6.7 STADIUM ACCESS

BMD01-PAT-ZZ-ZZ-RP-Z-000002 The People's Project Design and Access Statement Addendum

Level 00

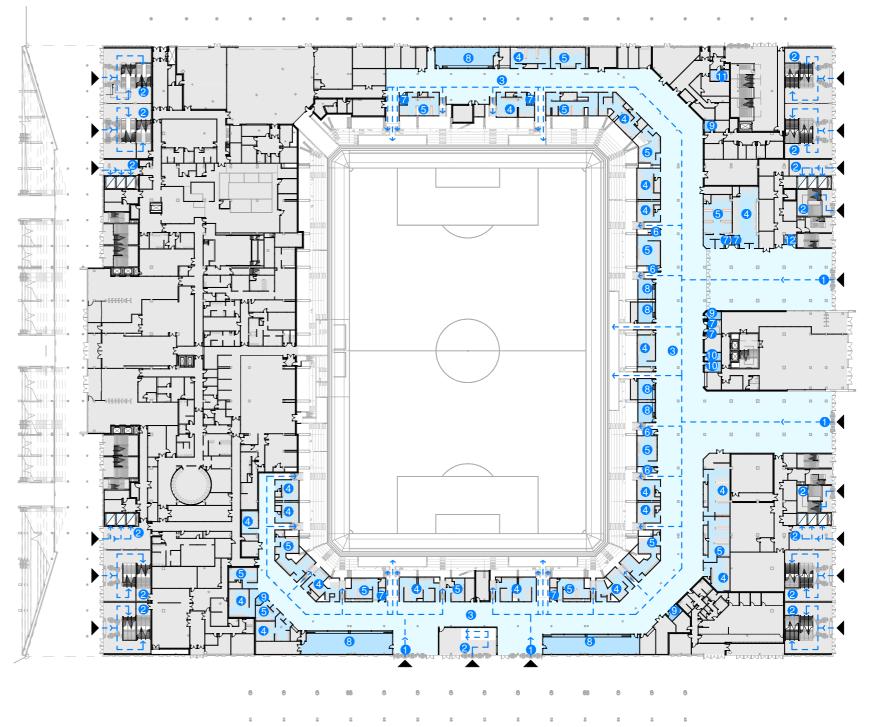
Access to the stadium for GA spectators is very similar to the scheme submitted in December 2019. The entrances for the lower tier are along in east and south facades. The main east entrances have been simplified so that there are two large entrances, rather than three smaller ones. Access to the upper tier is via the corner stairs, corner lift lobbies and the south escalators. Each type of access has a different entry which will be clearly signed from the outside. There has been an increase in the overall number of turnstiles to reduce queuing times and in line with SGSA guidance.
